Project	IEEE 802.16 Broadband Wireless Access Working Group http://ieee802.org/16 >					
Title	Closed loop power control for FDD					
Date Submitted	2008-03-18					
Source(s)	Jaehee Cho Voice: +82-31-279-5596 Email: iaahaal aha@samsung.com					
	E-mail: jaehee1.cho@samsung.com June Moon					
	YongSeok Kim					
	Kwanhee Roh					
	Changyoon Oh					
	Samsung Electronics #416, Maetan-3dong, Yeongtong-gu Suwon-city, South Korea					
	Anuj Puri					
	Beceem					
Re:	P802.16Rev2/D1					
Abstract	This contribution provides new MAP IE for closed loop power control. It shows performance gain of closed loop power control over open loop power control in FDD mode. The performance gain motivates a frequent transmission of closed loop power control command. The proposed new MAP IE provides sufficiently lower overhead compared to the current power control messages in the specifications. The propose new MAP IE support CLPC based on UL traffic burst and CQICH.

Closed loop power control for FDD

Jaehee Cho, June Moon, Yongsuk Kim, Kwanhee Rho, Changyoon Oh Samsung Electronics Anuj Puri Beceem

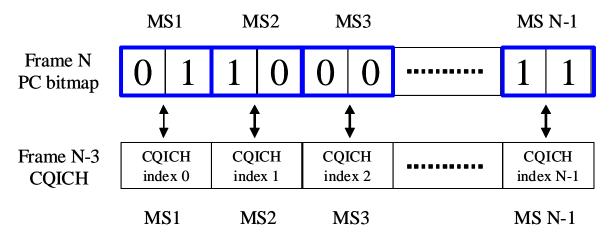
The following diagram illustrates the concept of the proposed power control signaling scheme. In Frame N-3, N MSs send CQI in CQICHs in UL CQICH region. In frame N, a power control bitmap is constructed. In the bitmap, total N 2-bits power control commands are arranged in the same MS order as in the CQICH region in the Frame N-3. No explicit MS identifier is needed to deliver the power control command to a MS.
